**Re: Initial Submission Review – Crippen Property – Zoning Map Amendment and Master Plan**

Application Number: **DA-1435-02**

Case Numbers: **2000-2027-02; 2023-7007-00**

# Initial Submission Review

Context Map (1/2 mile perimeter)

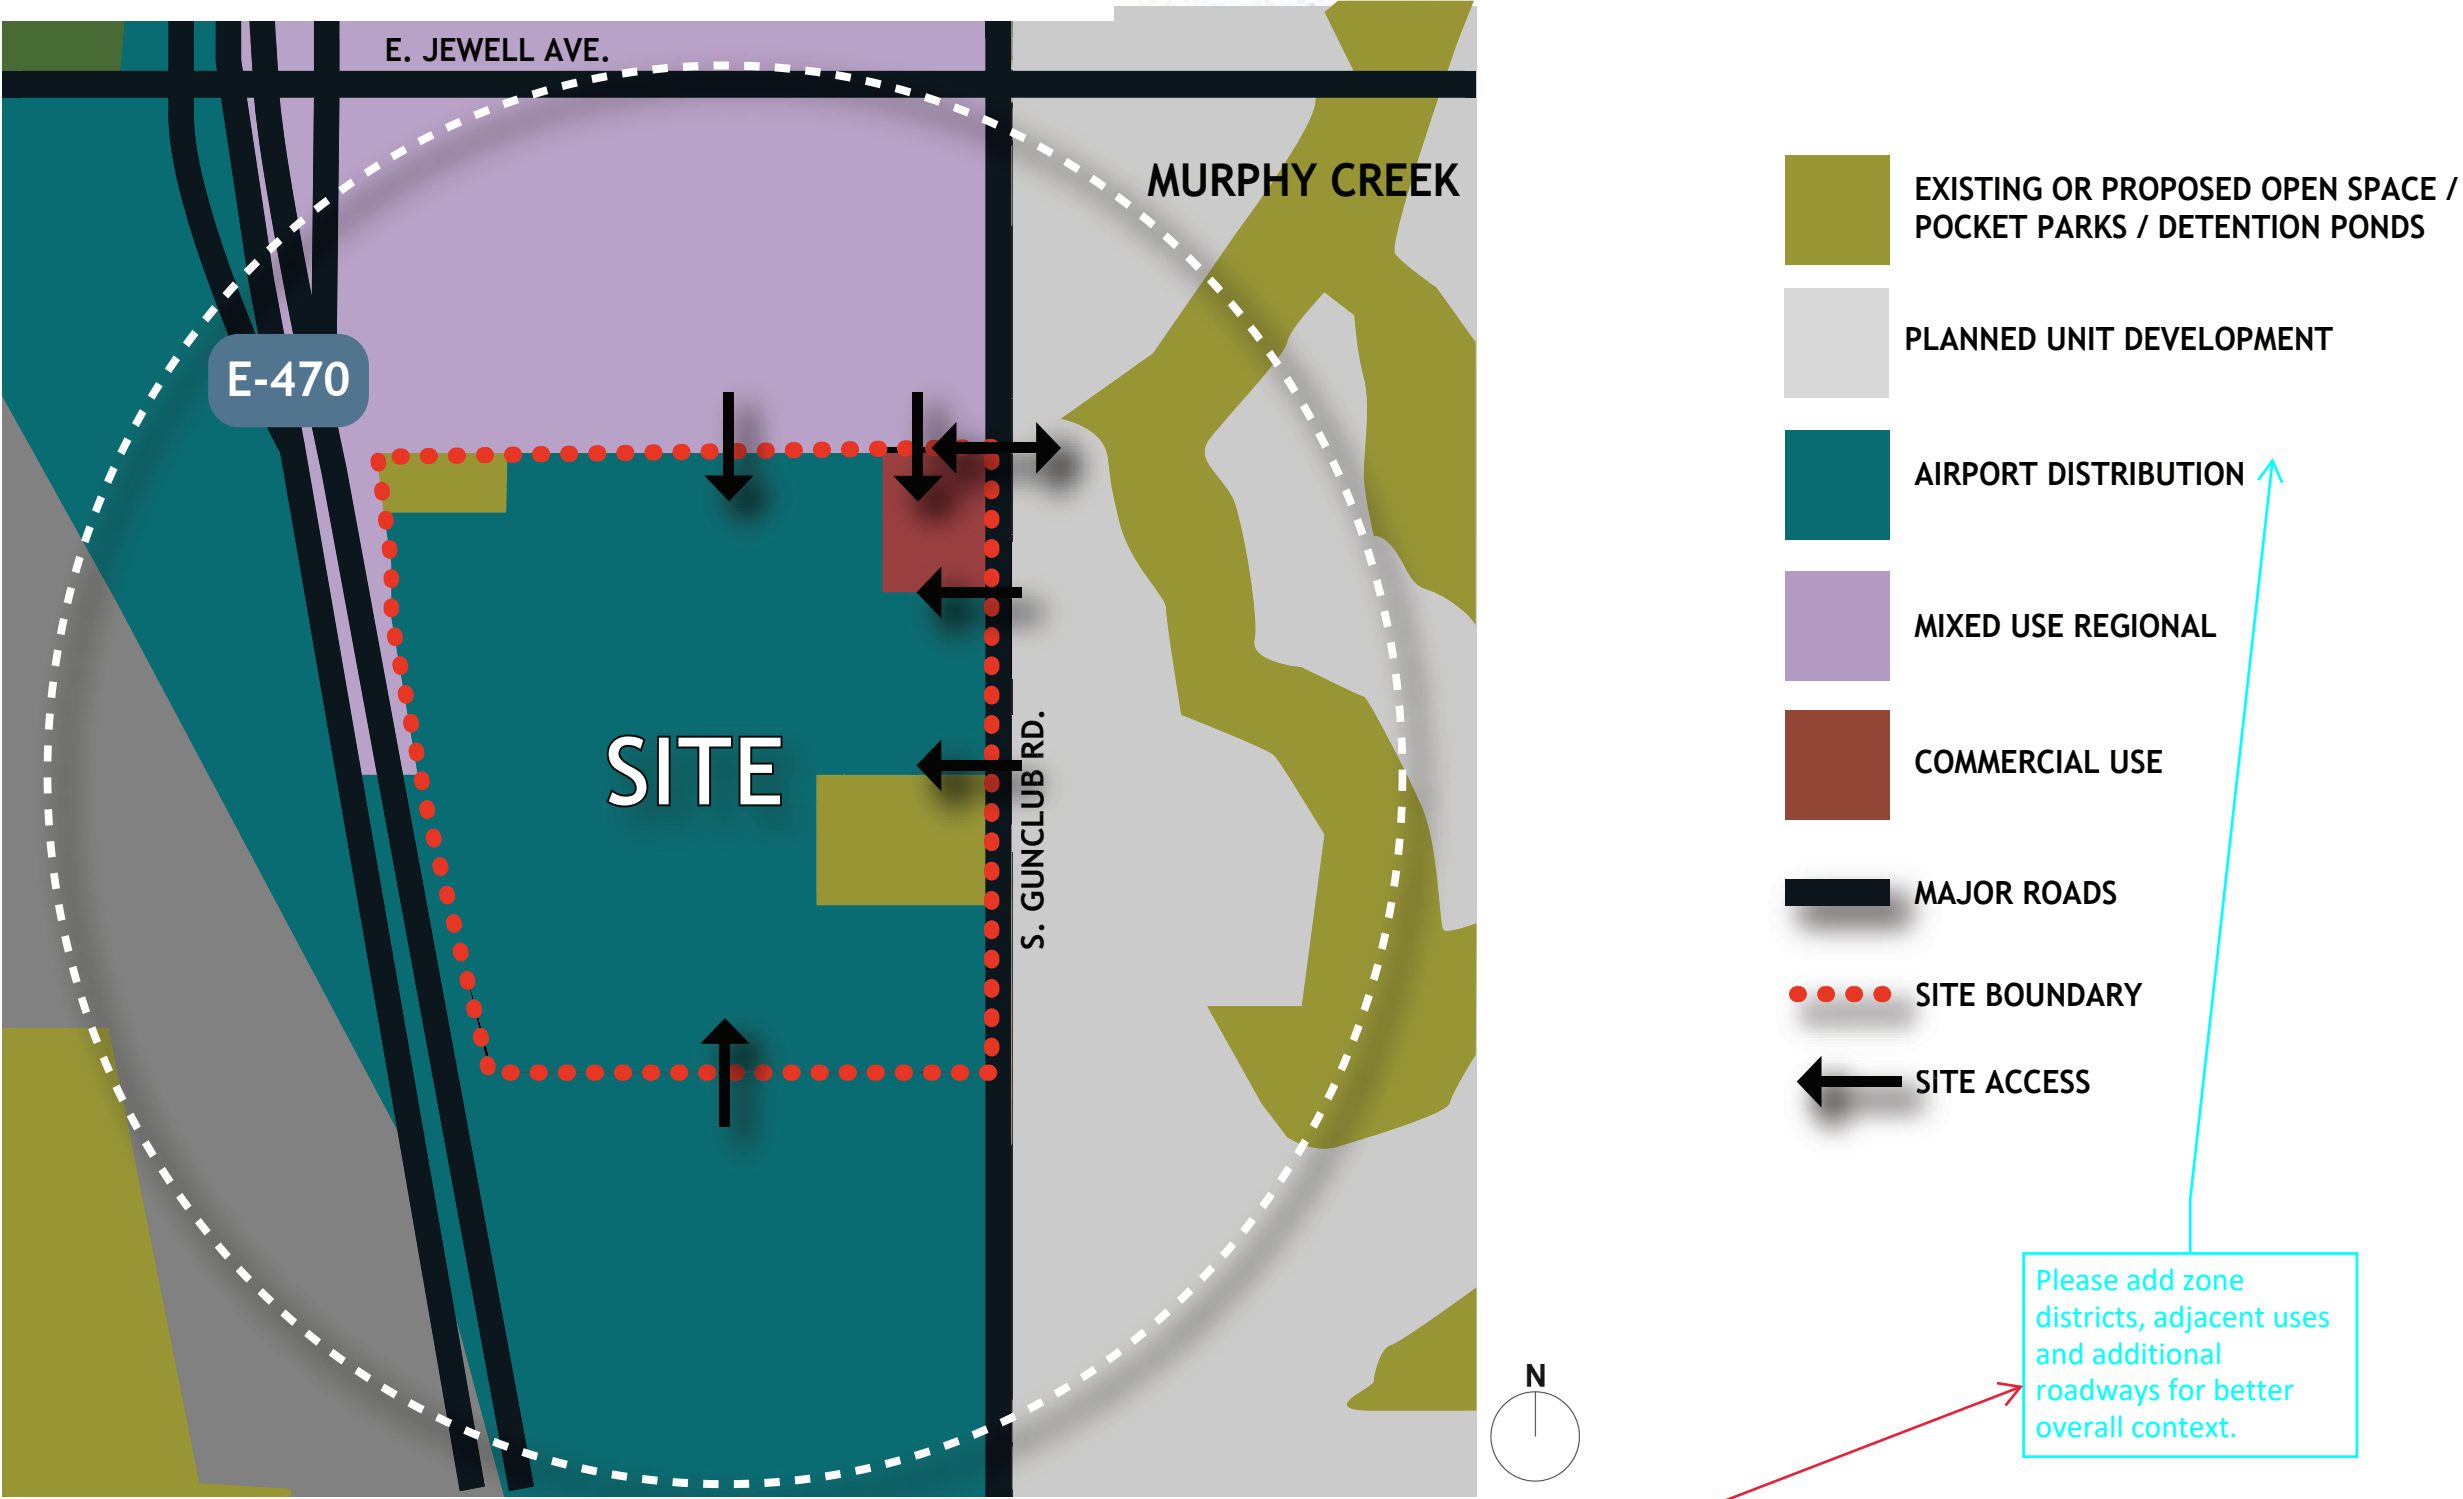
Please add zone districts, adjacent uses and additional roadways for better overall context.

RESPONSE: NOTED.  
ADDITIONAL INFORMATION  
ADDED.

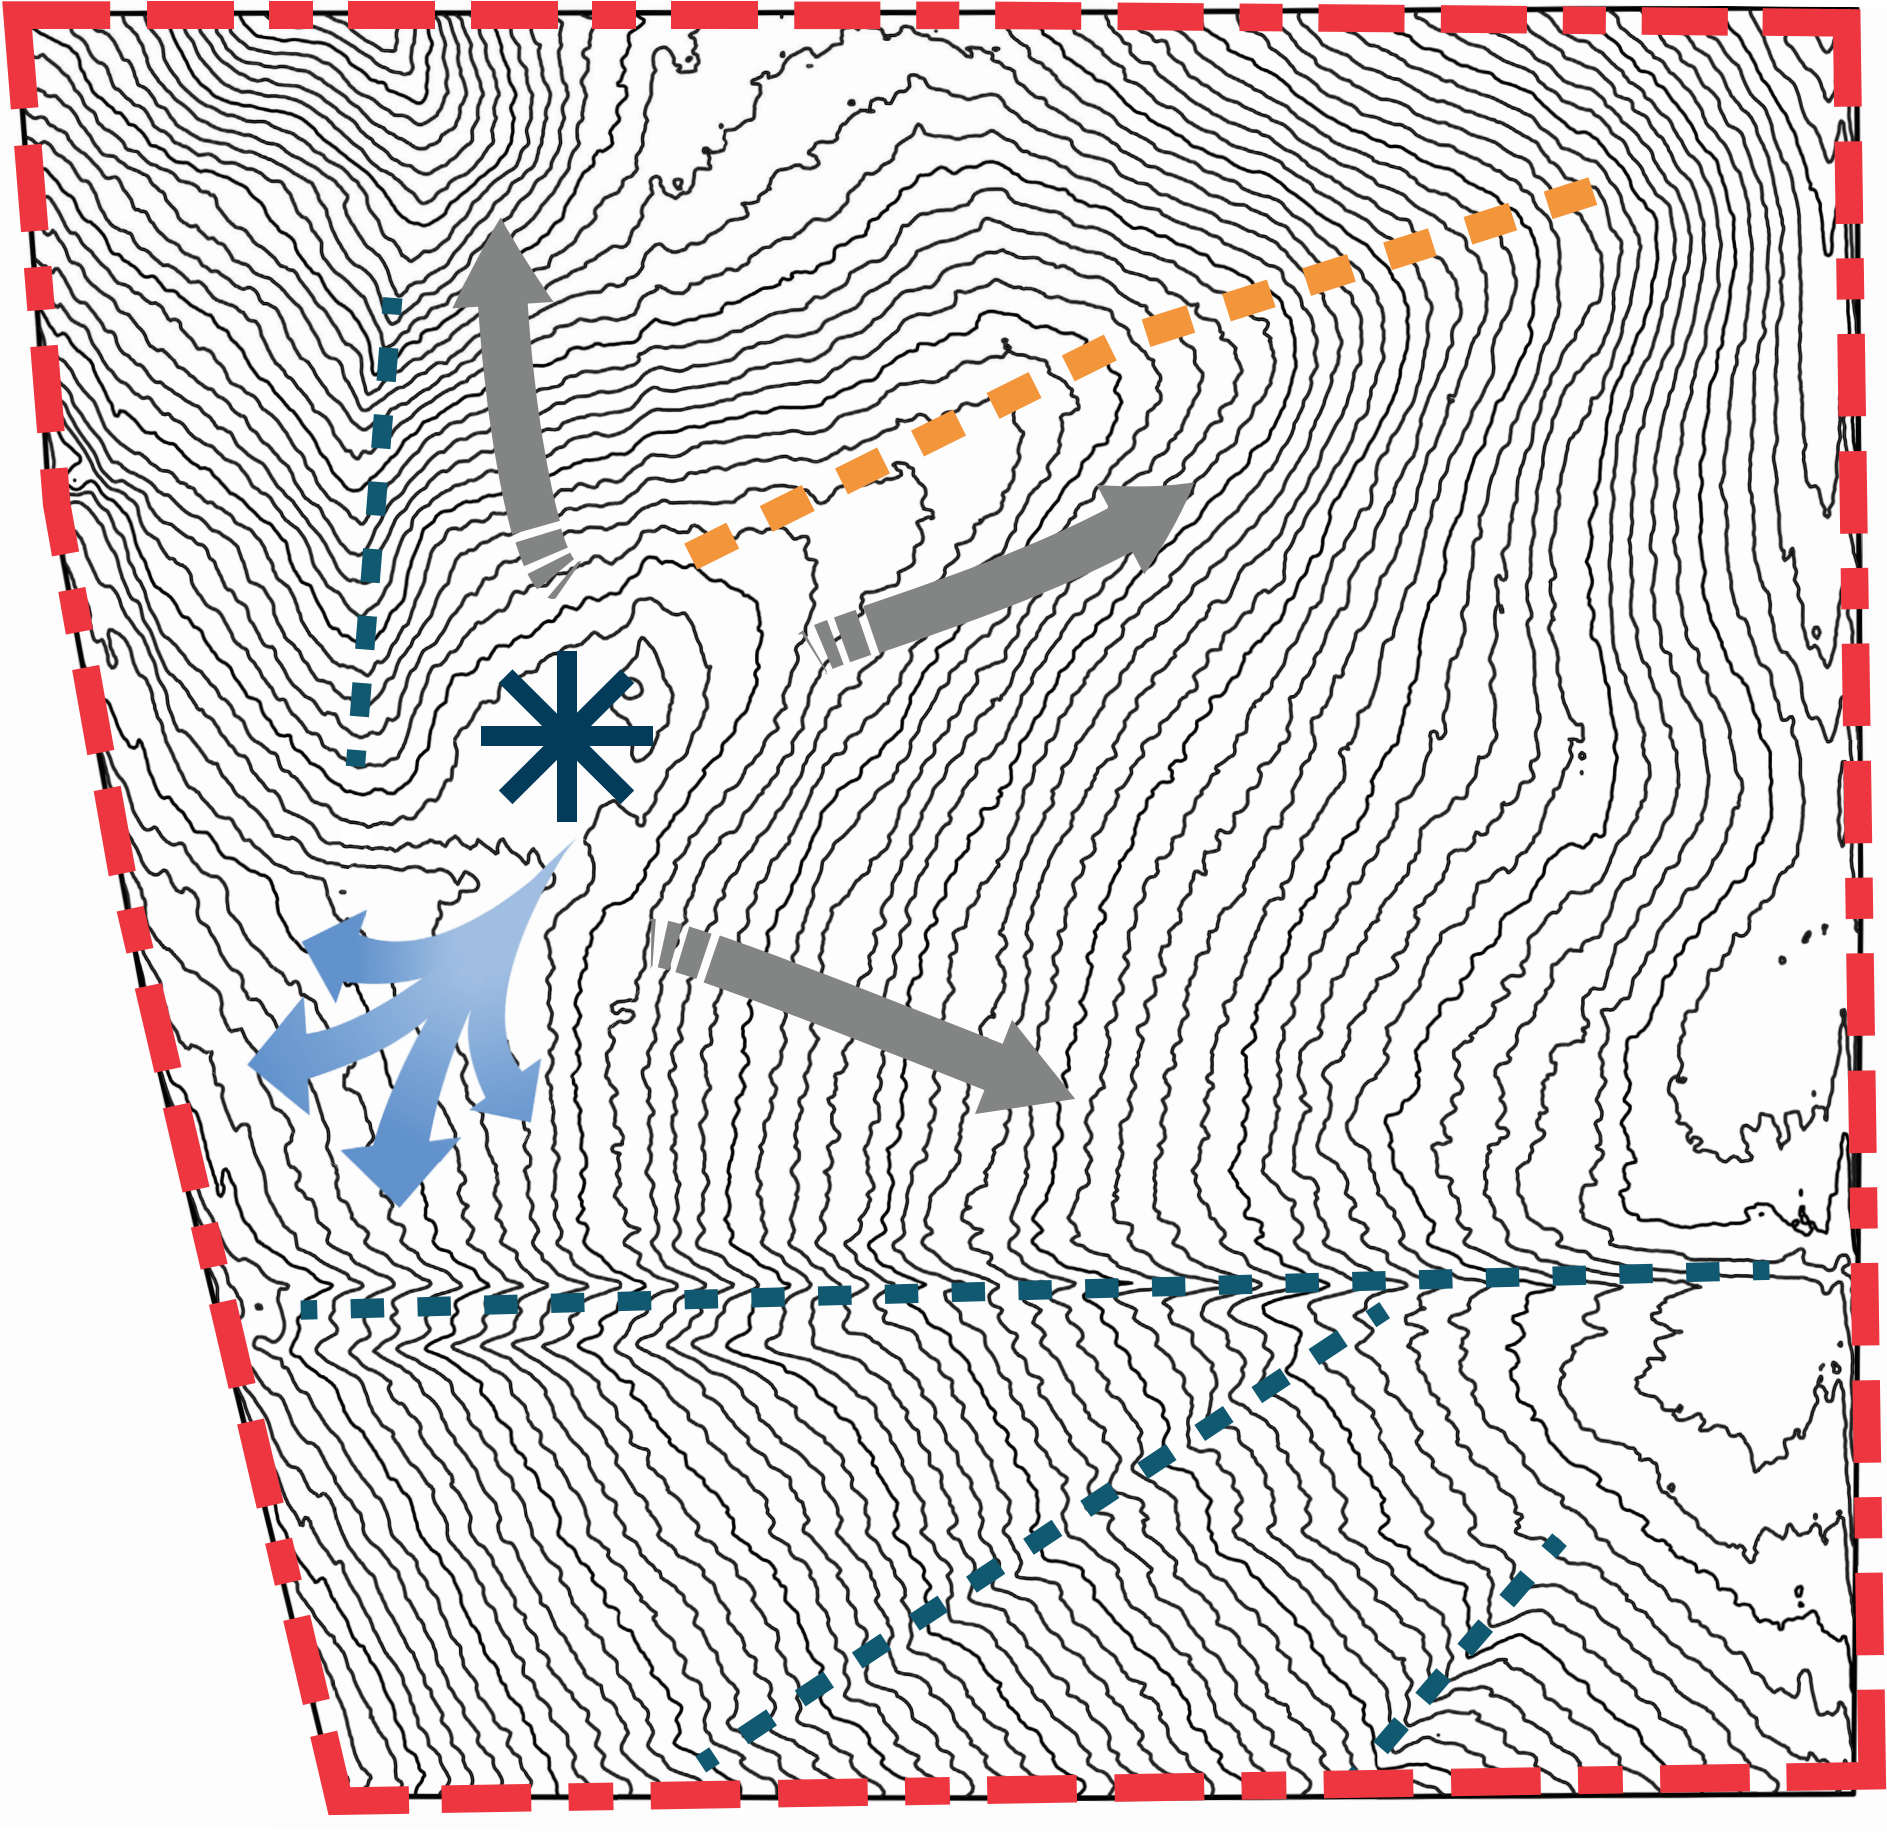
Please provide additional benefits for this location: Per the Master Plan Manual these items are required for this map:

- 100-year floodplain areas
- Streams, lakes or ponds, or wetlands
- Simplified contours at 10-foot intervals indicating slope direction
- Major high points, ridges, and drainage ways
- Any existing airport overlay district boundaries
- Any environmental hazards or conditions that may exist including (but not limited to) landfills, unexploded ordnance, groundwater pollution plumes, etc.
- Historical or archeological sites as defined by federal, state, or local governments
- Existing roadways or structures
- Existing easements, power lines, railroad rights-of-way, etc.
- Boundaries of any jurisdictions or service districts on or adjacent to your property such as fire districts, school districts, water, and sewer districts, etc.

RESPONSE: THERE IS NO 100- YEAR FLOODPLAIN AREAS, STREAMS LAKES, PONDS, OR WETLANDS ON SITE. CONTOURS SIMPLIFIED TO ONLY MAJOR CONTOURS. HIGH POINTS AND RIDGES, DRAINAGE ARE INCLUDED. AIRPORT DISTRIBUTION DISTRICT ADDED TO MAP. THERE ARE NO ENVIRONMENTAL HAZARDS/ CONDITIONS OR ARCHEOLOGICAL SITES ON SITE. THERE ARE ALSO NO EXISTING ROADWAYS OR STRUCTURES. THE EXISTING EASEMENT IS SHOWN ON MAP.

**TAB 8**  
MASTER PLAN LAND USE MAP

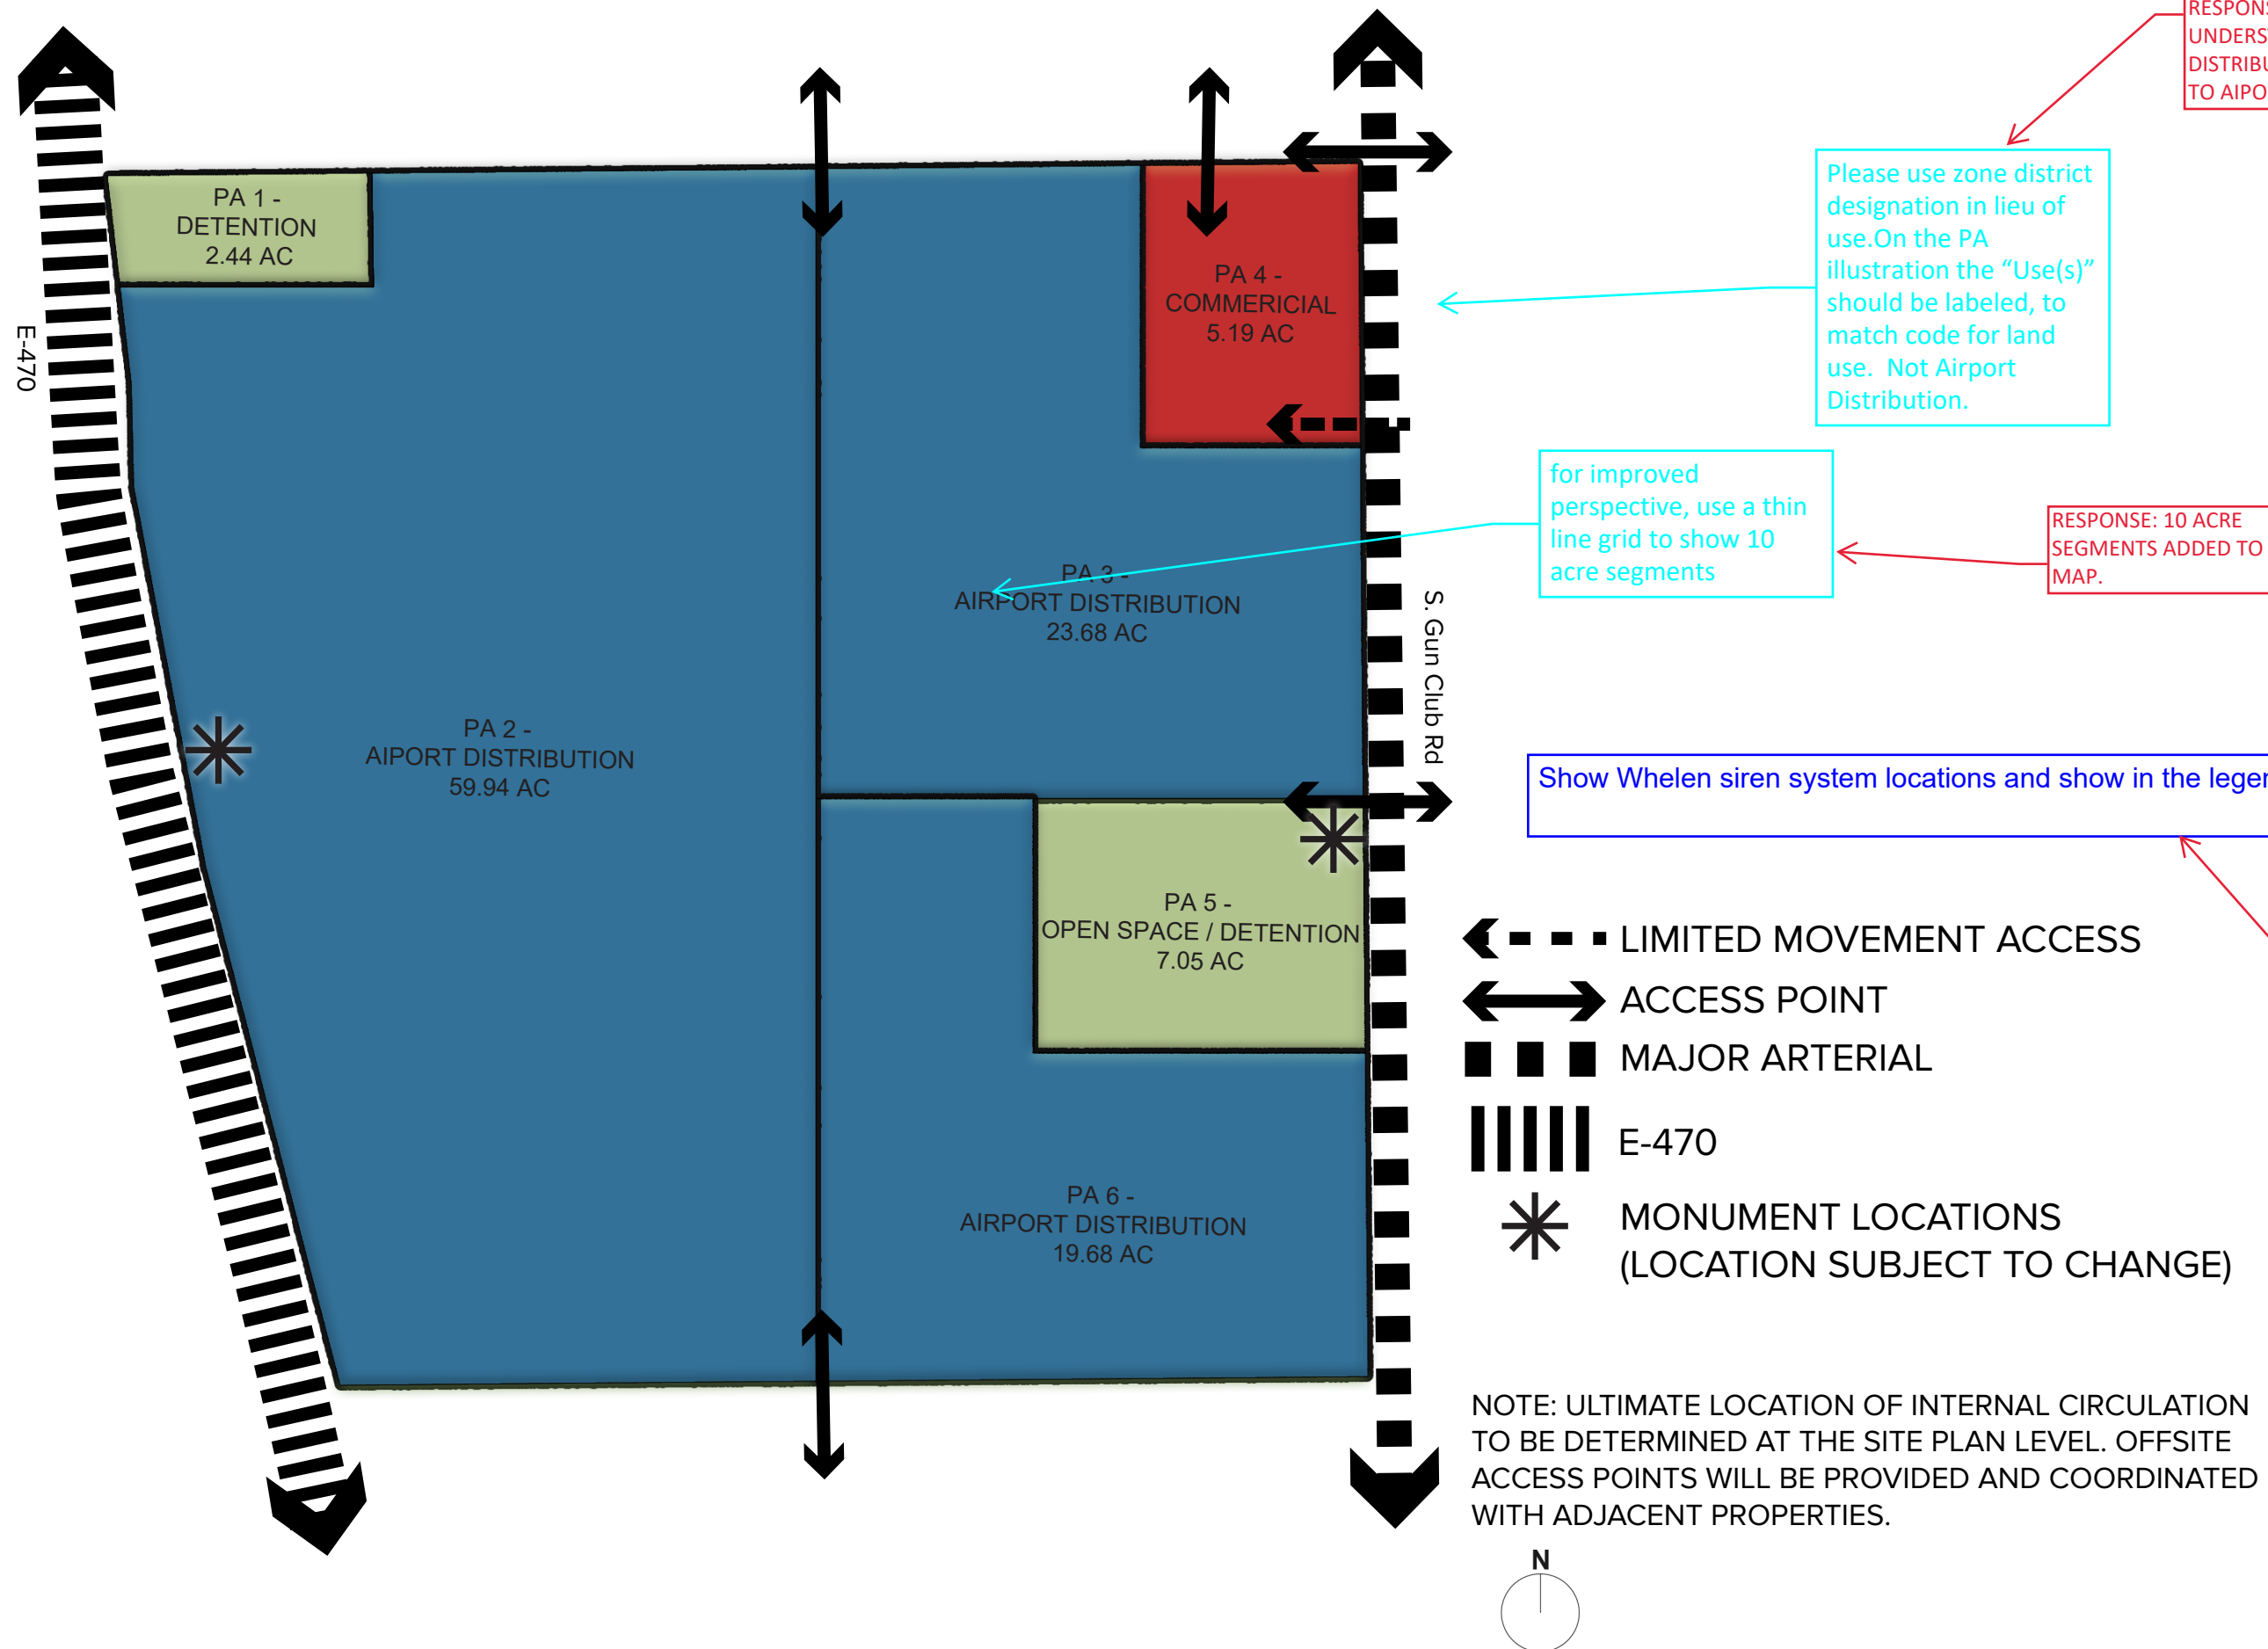
Please use zone district designation in lieu of use. On the PA illustration the "Use(s)" should be labeled, to match code for land use. Not Airport Distribution.

RESPONSE: 10 acres segments added and airport distribution changed to airport district.
